Renewing

1073-10572/1

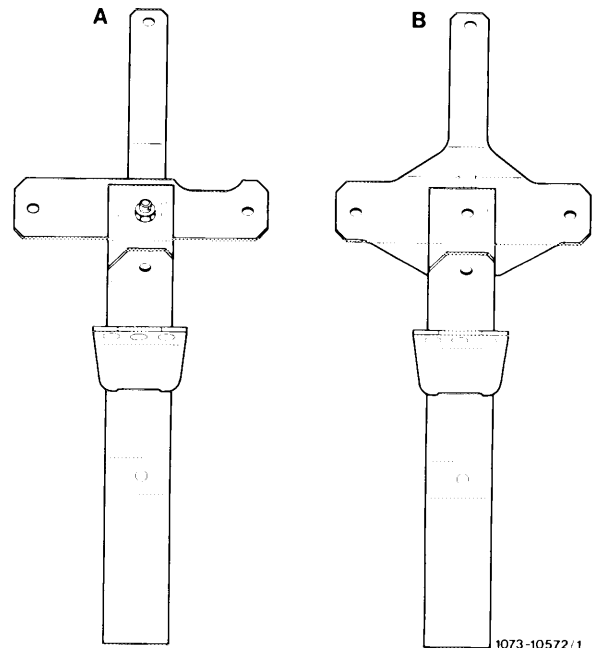
The holder has been modified to improve installation
position and to increase rigidity.

A 1st version
B 2nd version

For renewing holder, remove
fuel reservoir (07.3–270),
fuel filter (07.3–275),
fuel pump (07.3–280).
